Airport Land Use Commission

Subject: FSRE Industrial Concord Project, County File# DP21-03022

Project Title:	FSRE Industrial Concord Project
ALUC File #:	County File# DP21-03022
Lead Agency:	Contra Costa County
Applicant/Owner:	FSRE Industrial Concord Company, LLC/Contra Costa County
Site Address/Location:	Buchanan Field's western edge between Marsh Drive and Sally Ride Drive
Staff Recommendation(s):	APPROVE (see Staff Report Section VI)
List of Exhibits:	Exhibit A: Proposed Project Plans Exhibit B: Solar Glare Hazard Report Exhibit C: FAA Aeronautical Study
Staff Contact:	Jamar Stamps, AICP, (925) 655-2917

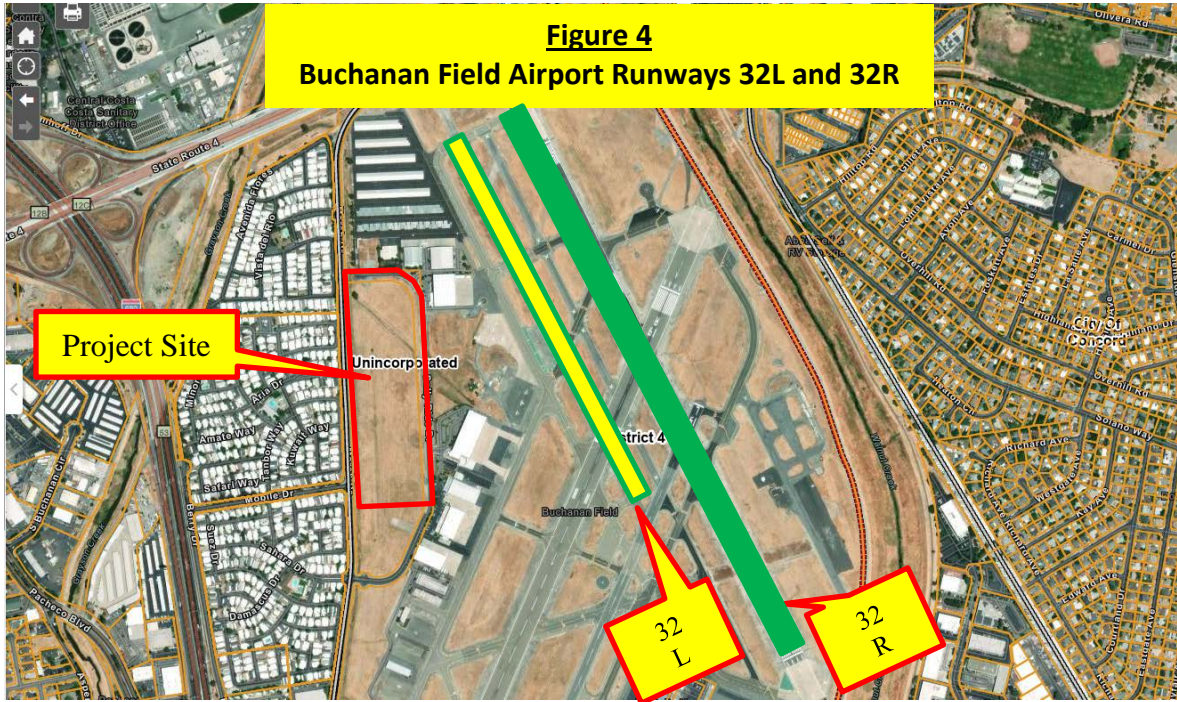
The proposed project’s solar glare hazard report concluded that the proposed PV solar energy system would not create glare that would result in a hazard to air navigation to 7 of the 8 final runway approaches or the Buchanan Field ATCT. However, the analysis shows 1,264 minutes of green and 1,161 minutes of yellow glare⁷ for the Runway 32L approach, and 931 minutes of green glare for the Runway 32R approach (Figure 4). According to FAA guidance, green glare is generally acceptable while yellow glare could have the potential for temporary after image.

As mentioned in the previous section, the latest 2021 FAA Glare Standards updated and replaced the previous 2013 policy including removing the requirement to evaluate glare for pilots on final approach. However, the Commission may determine the amount and duration of yellow glare is significant enough to warrant modification or removal of the proposed PV solar energy system.

TABLE 1

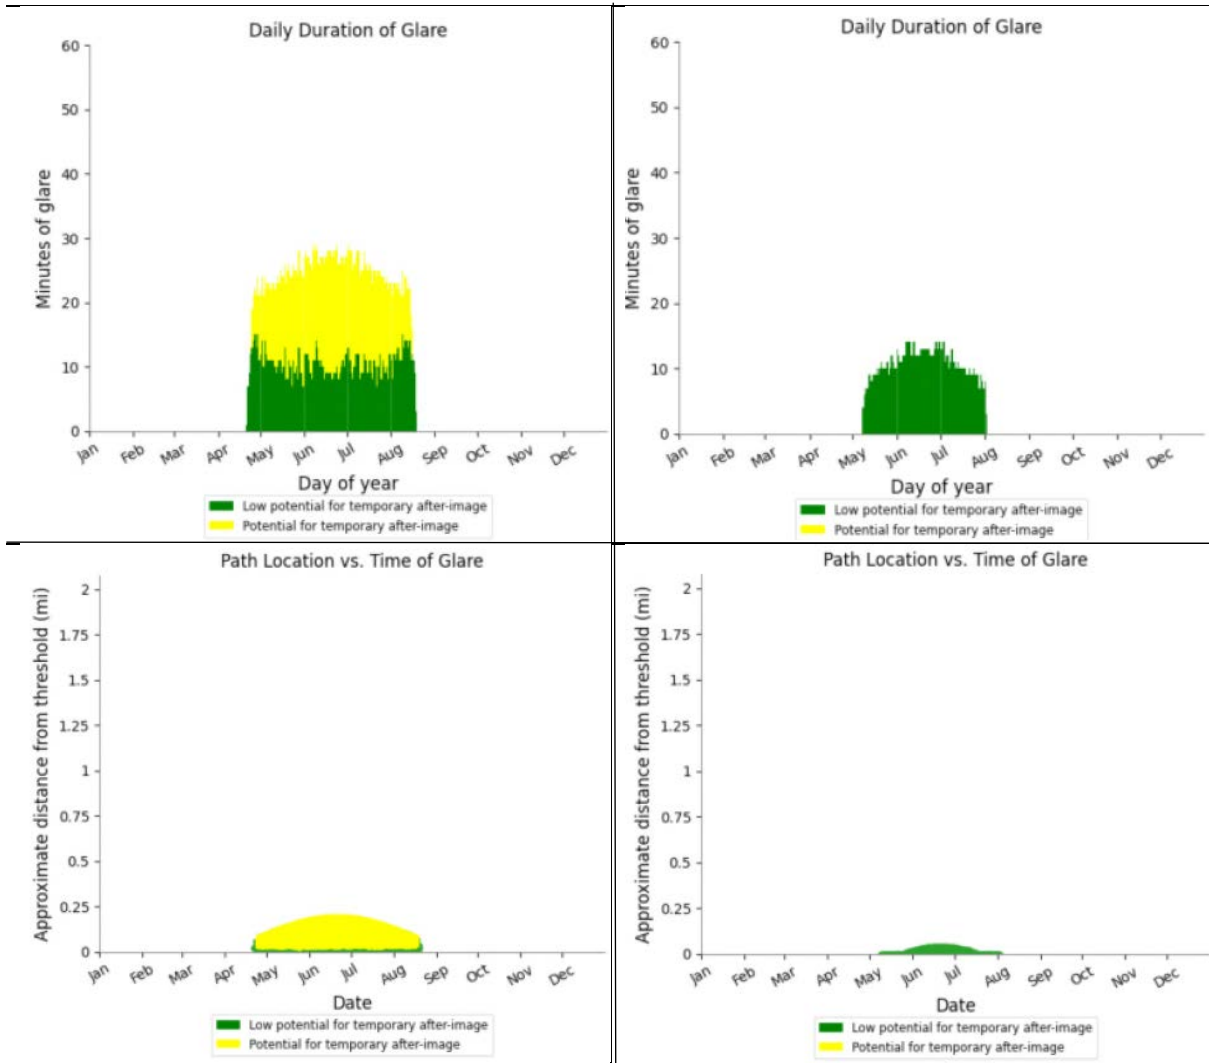
The time of year and duration of green and yellow glare for both runways is further illustrated below (Table 1, also see diagrams in Exhibit B). The model predicts this glare occurring within approximately 0.25 miles or less of the end of either final approach (i.e., within 0.25 miles or less of the end of the runway).

Flight Path: RWY 32L	Flight Path: RWY 32R
1,611 minutes of yellow glare	0 minutes of yellow glare
1,264 minutes of green glare	931 minutes of green glare
